2.6 Reactor Auxiliary Systems

The information in this section of the reference ABWR DCD, including all subsections, tables, and figures is incorporated by reference with the following departure to Figure 2.6.2.

Figure 2.6.2 Fuel Pool Cooling and Cleanup System

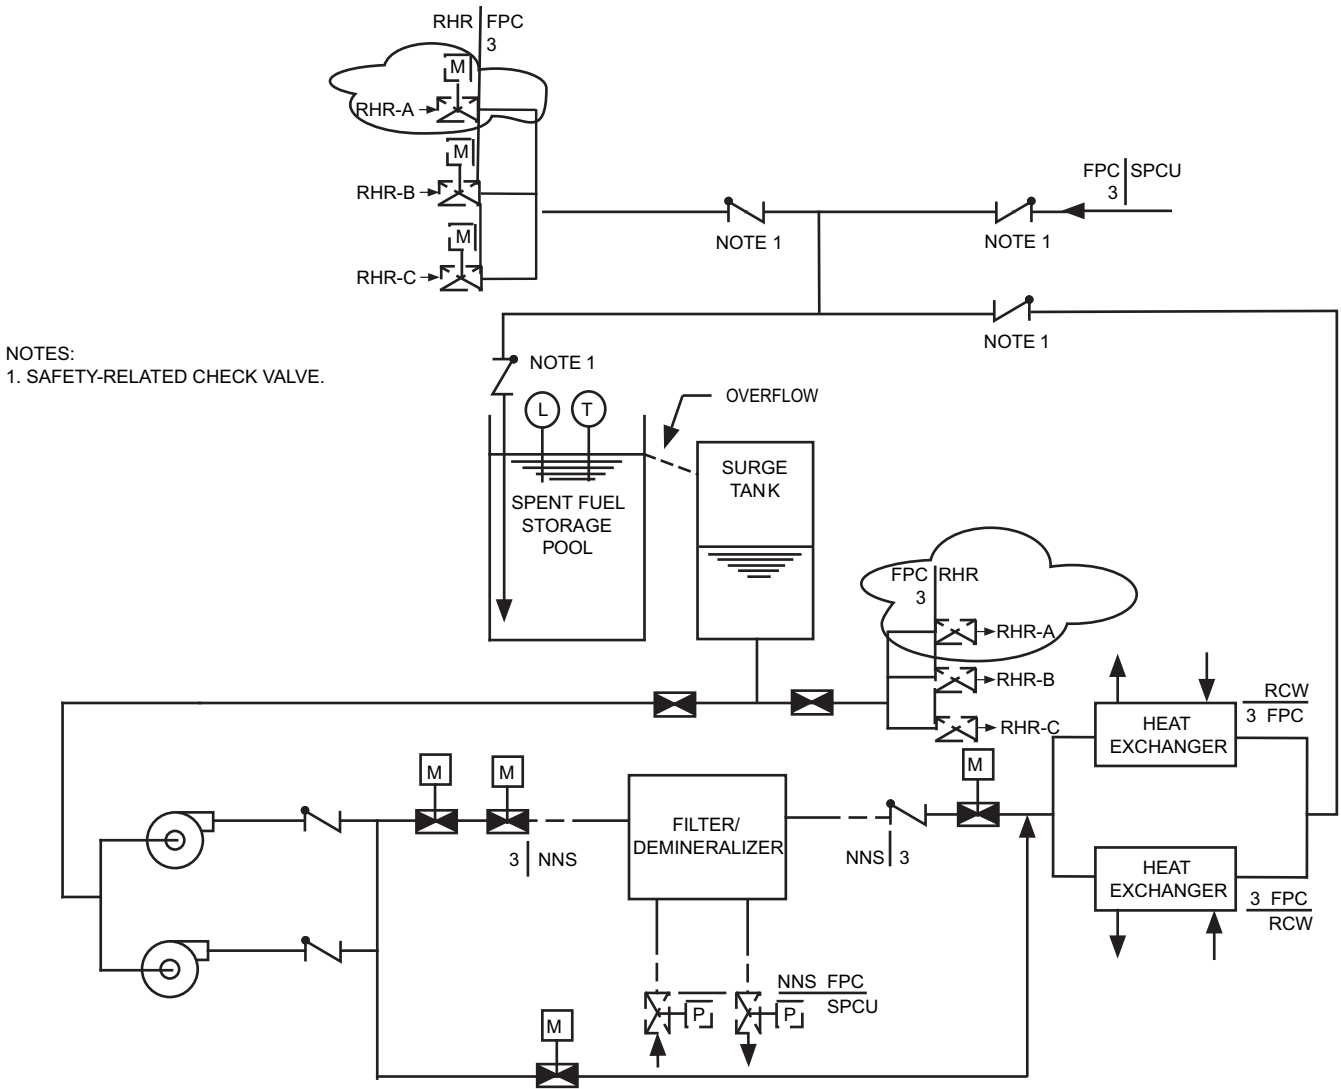
STD DEP T1 2.4-1
